## 22 STATE AGENCY COMMENTS

## Submission 1376 (Sean Allen, California Department of Fish and Wildlife, May 27, 2020)

## Submission 2070 (Julie Vance, California Department of Fish and Wildlife, June 23, 2020)

**Objective:** The San Jose to Merced Project Section (Project Section) would provide High-Speed Rail (HSR) service from Scott Boulevard, just north of the San Jose Diridon Station, to a station in downtown Merced. The Project Section consists of three separate portions: San Jose to Central Valley Wye, Central Valley Wye, and Ranch Road to Merced. The portion of the Project Section analyzed in the *San Jose to Merced Project Section Draft Environmental Impact Report (DEIR)/Environmental Impact Statement (EIS)* is from Scott Boulevard, just north of San Jose Diridon Station, to Carlucci Road. This is referred to as the San Jose to Central Valley Wye Project Extent (Project or Project Extent). It would extend approximately 90 miles, passing through Santa Clara, San Benito, and Merced Counties and the cities of Santa Clara, San Jose, Morgan Hill, Gilroy, and Los Banos.

Figure 1. The Authority's flow chart documenting the fault screening process.

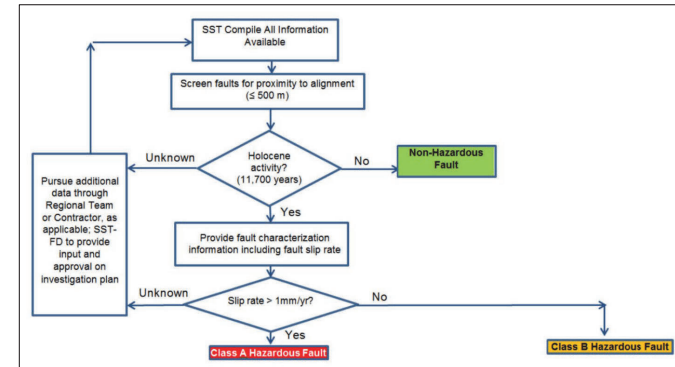
The primary seismic hazard of surface fault rupture is addressed in a series of background reports. Lettis Consultants International (LCI) produced three fault evaluation reports dated April 2017 that explain the process for screening fault hazard (Figure 1) and document the known properties of faults that cross or are within 1 650 feet (500 meters) of the project. The hazard of each fault is then classified in a separate report prepared by the Seismic Specialist Team – Fault Displacement (SST-FD) dated July 2017. The LCI reports indicate that faults classified as either Class A Hazardous or Class B Hazardous would then be subject to a fault displacement hazard analysis

The fault evaluation reports by LCI adequately characterize faults in the project area. However CGS notes the SST-FD report classifies the Monte Vista-Shannon fault as nonhazardous which does not appear to be consistent with the Authority's screening process (Figure 1) considering the data presented in the fault evaluation report. LCI concluded the Monte Vista-Shannon fault is an active fault with a slip rate of less than 1 mm/yr and that additional work is warranted to confirm or disconfirm mapping that shows the fault as potentially intersecting the project. **CGS recommends that a nonhazardous classification for the Monte Vista-Shannon fault should be supported by additional work as specified by LCI.** Alternatively a conservative approach would be to classify the fault as Class B Hazardous consistent with the Authority's screening process.

Figure 2. Lands classified as MRZ-2 in the Pacheco Pass area.

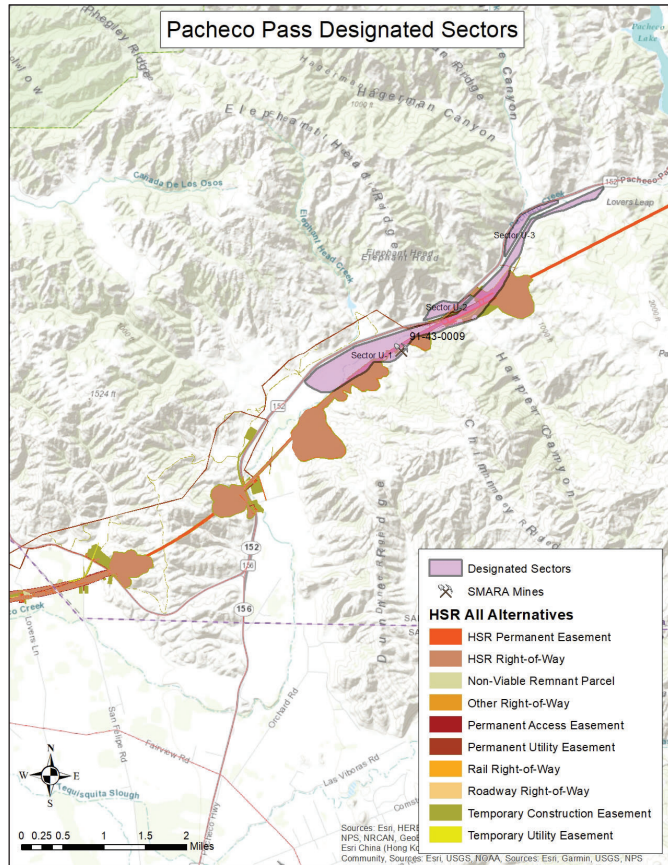
CGS finds that this project section of the HSR is on lands classified MRZ-2 and designated as containing aggregate deposits of regional significance in an area along the Pacheco Pass east of Gilroy (Figure 2). The designated area contains about 19 million tons of concrete grade aggregate resources. The proposed project is a land-use incompatible with mining.
